Esquire Knit Composite

17th September 2013

Priority Actions

Heavy loading

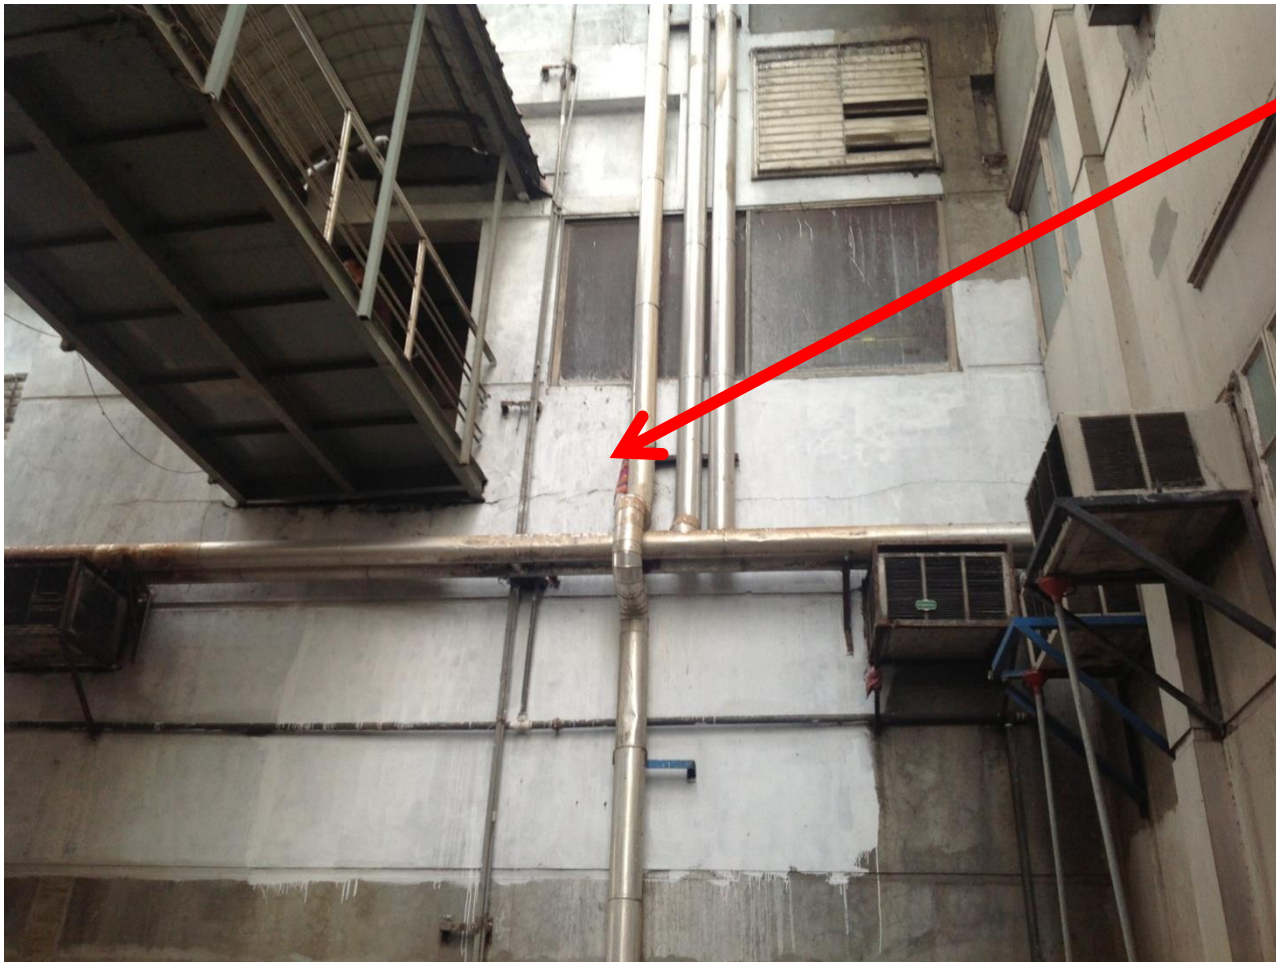
**Dense Storage up to approx
16KN/m² noted on some
levels**

ITEM 3: Heavy loading on some levels - Risk of overloading or local damage to slab

**Plan and height restrictions
to be introduced to prevent
future overloading.**

**Heavy Equipment Loading
on suspended floors –
Floor slabs to be checked
against loading given on
equipment data sheets**
